ST. CHARLES <small>SINCE 1834</small>	HISTORIC PRESERVATION COMMISSION AGENDA ITEM EXECUTIVE SUMMARY			
	Agenda Item Title/Address:	COA: 101 S. 2 nd St. (Baker Community Center)		
	Proposal:	Renovations to structure		
	Petitioner:	Kluber Architects & Engineers		
Please check appropriate box (x)				
	PUBLIC HEARING		MEETING 5/4/16	X
AGENDA ITEM CATEGORY:				
<input checked="" type="checkbox"/>	Certificate of Appropriateness (COA)		Façade Improvement Plan	
	Preliminary Review		Landmark/District Designation	
	Discussion Item		Commission Business	
ATTACHMENTS:				
Architectural plans				
Renderings				
Minutes from 2/17/16 and 3/16/16				
EXECUTIVE SUMMARY:				
<p>Proposed are alterations to the Baker Community Center. The Commission conducted a Preliminary Review for this project on 2/17/16 and 3/16/16.</p> <p>The proposed alterations are in line with the renderings reviewed at the 3/16/16 meeting.</p>

Baker Community Center Capital Improvements Project Presentation of Proposed Exterior Modifications March 16, 2016

6. Preliminary Review: Baker Community Center, 101 S. 2nd St.

7. Preliminary Review: Baker Community Center, 101 S. 2nd St.

Exterior View from south-concept
(see following page for more detailed image)

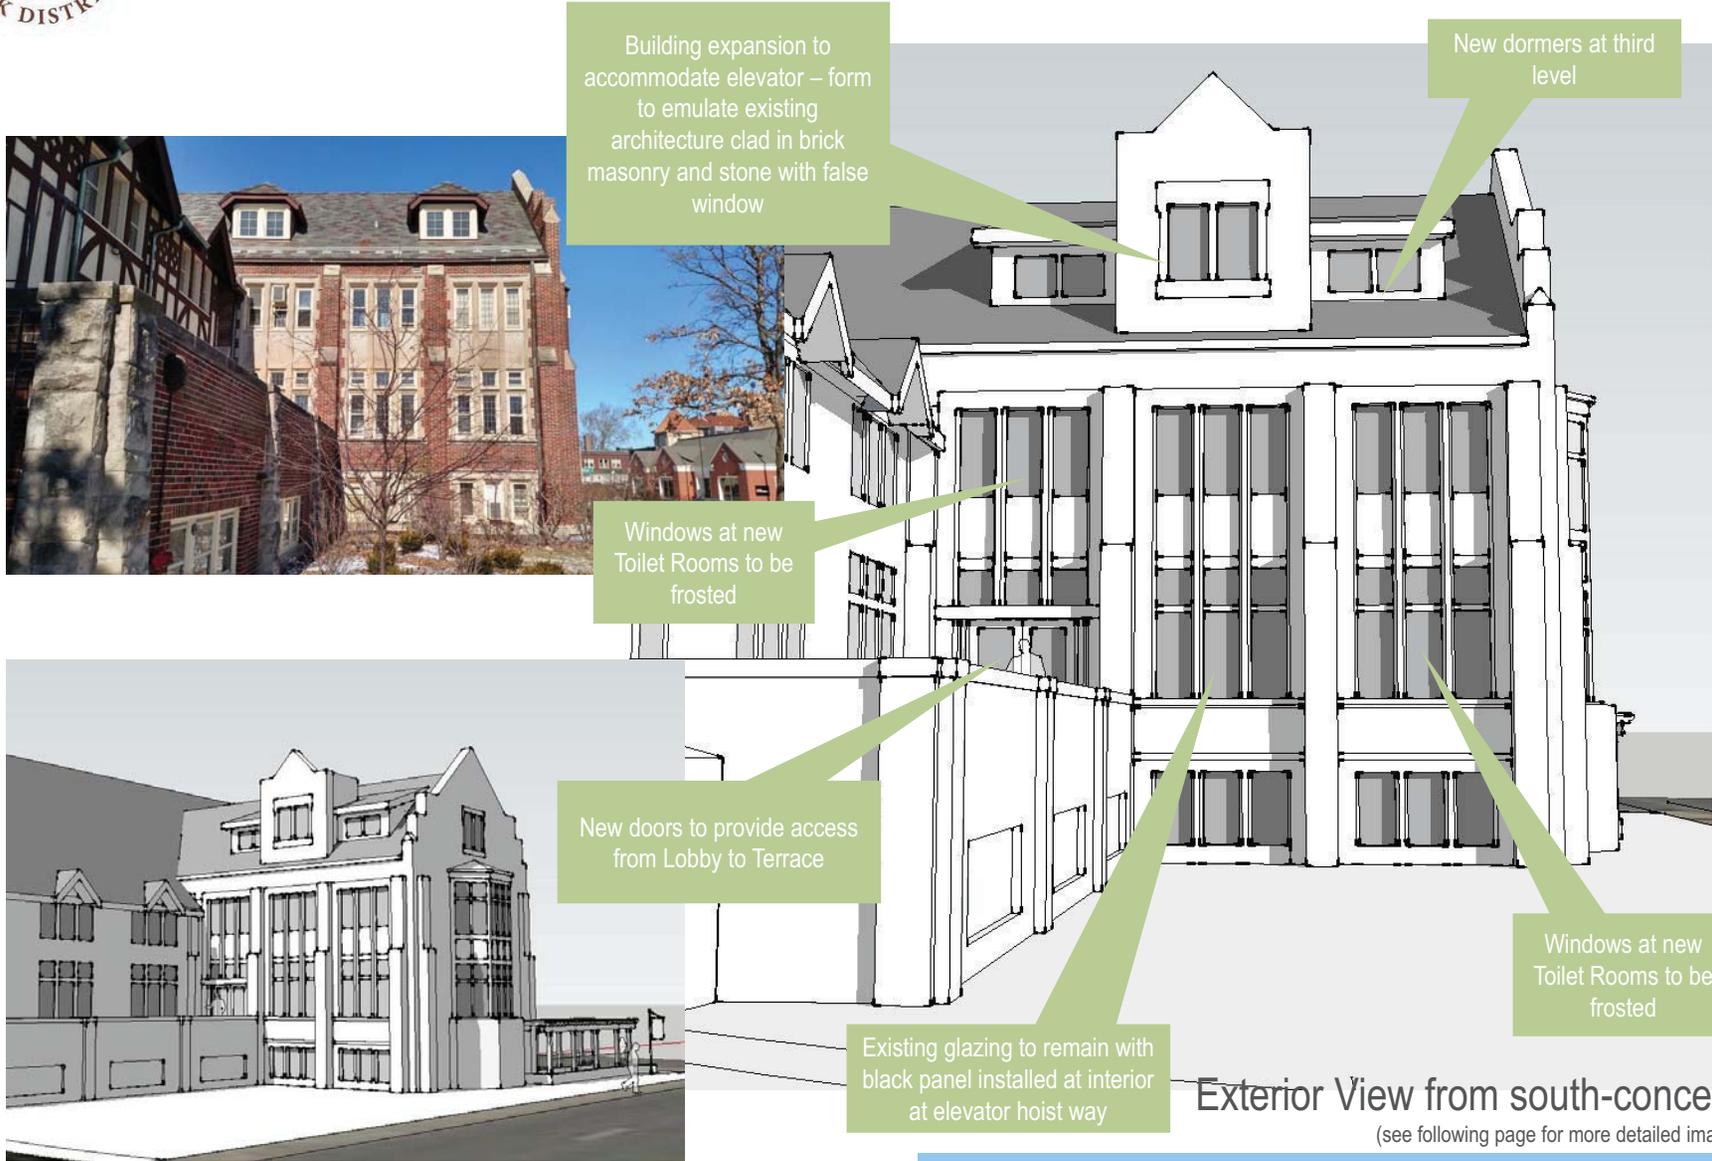
Building expansion to accommodate elevator – form to emulate existing architecture clad in brick masonry and stone with false window

New dormers at third level

Windows at new Toilet Rooms to be frosted

New doors to provide access from Lobby to Terrace

Windows at new Toilet Rooms to be frosted

Existing glazing to remain with black panel installed at interior at elevator hoist way

Mr. Elliot reviewed some slides pointing out the building improvement items that were discussed at the previous meeting. He said they are adding toilets so the windows in the new restrooms will be frosted. The windows in the center of the building will have blacked out panels inserted

from behind in order maintain the existing window. He pointed out the expansion projecting out of the roof. He said this is being added to the building to accommodate the new elevator.

Mr. Elliot said they are replicating the window divisions and those aspects of the building to push out the back. He noted the brick and stone trim will match what is on the building. He said the dormers will also be detailed to match. The roofs will be clad in copper. He said they are trying to use all the existing building elements in any adjustments they are making.

Mr. Elliot mentioned they are changing the set of doors that go from the lobby to the back terrace. He noted there currently is no way to access the terrace. Mr. Norris asked if the doors are going to be wood. He was informed they will be. Mr. Elliot said they removed the stairs from the terrace based on feedback from the previous meeting, but they may be added back at another time.

Exterior View from east

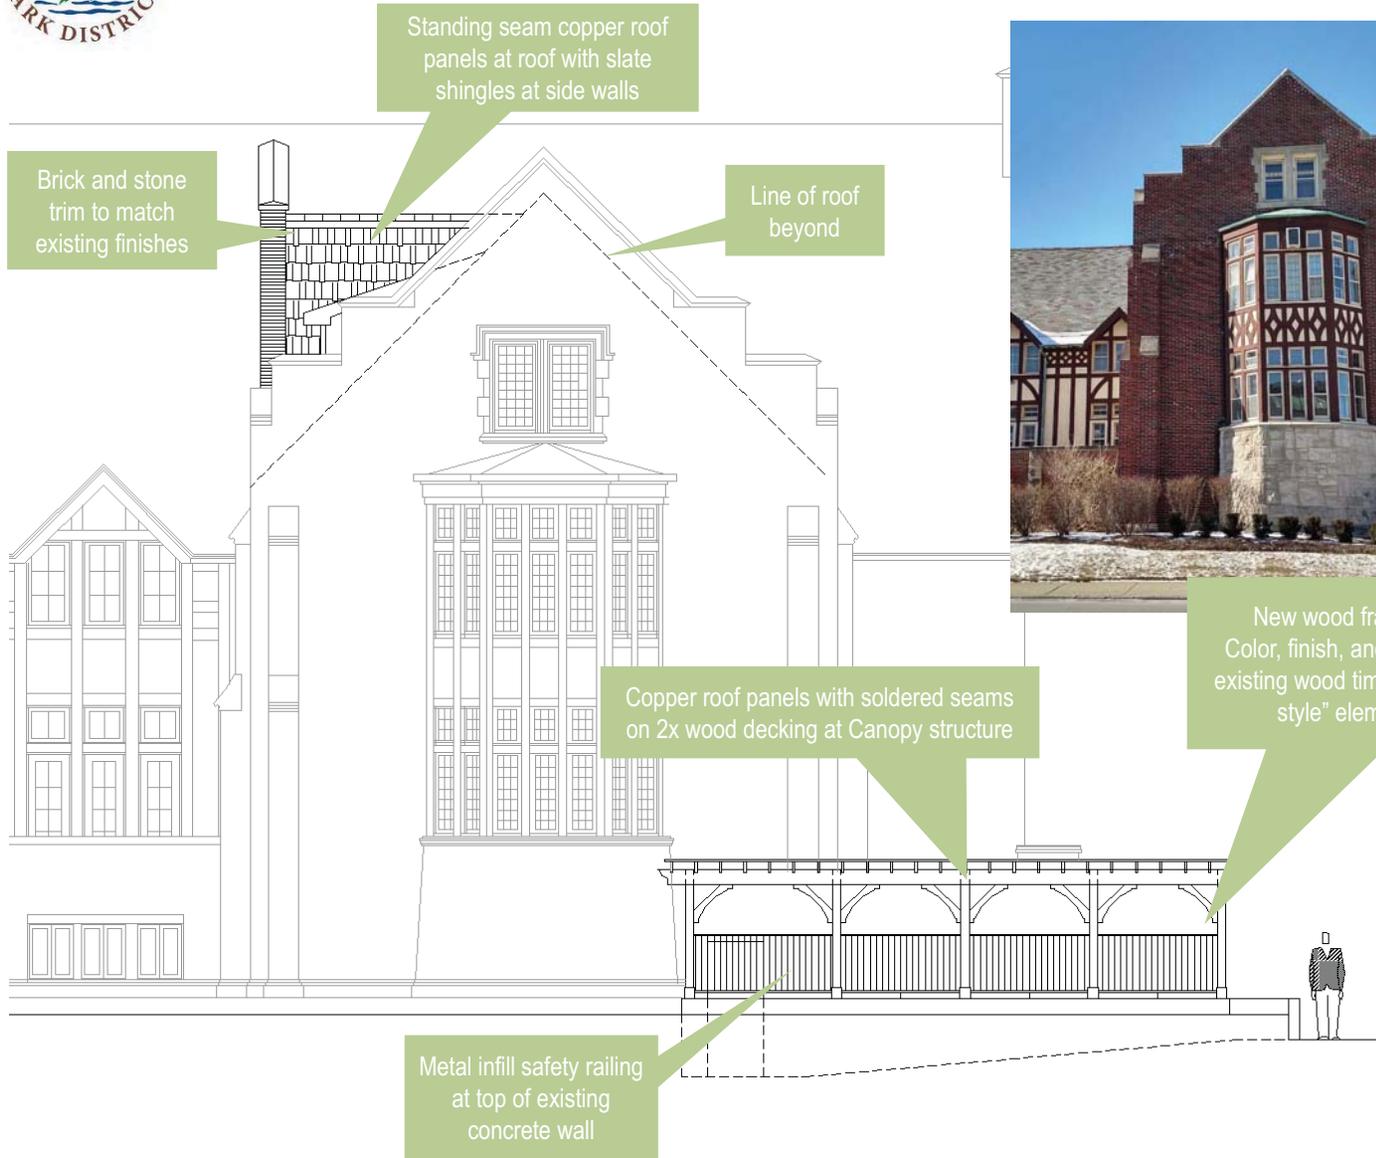
New wood framed canopy structure
Color, finish, and detailing to be based on existing wood timber and trim of the "Tudor-style" elements of the building.

New signage monument
directing people to
accessible entrance

Framed Canopy option at Ramp
(see detailed drawing on following page)

Mr. Norris asked if the dormer on top on the building will be made of brick, and if it would be load-bearing. Mr. Elliot said it will be concrete block and steel and will rest on the hoist weight going up in the elevator. Mr. Norris also asked about the stairway off the rear. He was concerned with them trying to put an exit where there wasn't one before. He asked if they could keep it from having too much of a presence. Mr. Norris suggested they consider adding a better stairway if it was going to be a grander exit.

Mr. Norris also suggested they consider using a canvas cover for the front accessible entrance, rather than the proposed wood pergola. Mr. Elliot was open to looking into that as an alternate cover. He said their initial idea was to provide some kind of weather cover for the existing ramp that goes into the accessible entrance. They intended to go with a garden structure to pull the tudor garden piece together. Chairman Smunt asked how much use this ramp gets. Mr. Marshall stated it gets used quite a bit, especially with the elderly population.

Mr. Elliot discussed the new wood framed canopy structure. He said they decided to go with an arbor trellis covering over the exterior ramp. The canopy roof will consist of copper panels with soldered seams. Mr. Norris asked if there will be any lighting on the structure. Mr. Elliot said there are existing side lights on the ramps. He said the previous rounded awning design resembled a bus shelter and they prefer the arbor idea.

Mr. Elliot mentioned they will also be adding some signage to one of the wing walls.
